**6-10 CAMBRIDGE TERRACE AND 1-2 CHESTER GATE, CAMDEN, NW1  
APPLICATION FOR LISTED BUILDING**

We write on behalf our client, Project Quad Limited, to seek Listed Building Consent for a new rooflight to replace that permitted by Planning Permission ref. 2009/3041/P and Listed Building Consent ref. 2009/3051/L and subsequently amended via a Section 73 application ref. 2015/1340/P and Listed Building Consent 2015/1817/L.

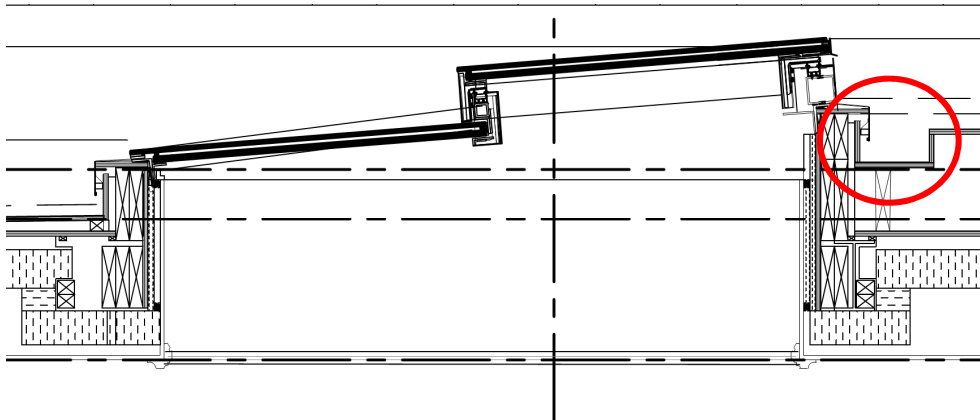
Due to Building Regulations, it has become necessary to make a further revision the proposed sliding roof light highlighted in red on drawing number SK02 – Roof Plan Key.

Building Regulations require roof lights to be proud of the prevailing roof plane by a minimum upstand of 150mm. This ensures that water ingress is prevented. The approved plans do not allow for this and thus the roof light cannot be constructed in its permitted form.

The new design approach means the full upstand height required by building regulations is achieved, with only a small amount of that height appearing above the prevailing roof line. This is achieved by sinking the window into the roof plane and using a sunken 'gutter' around the top of the window to achieve the necessary upstand height.

An extract below from the proposed section highlights the design feature.
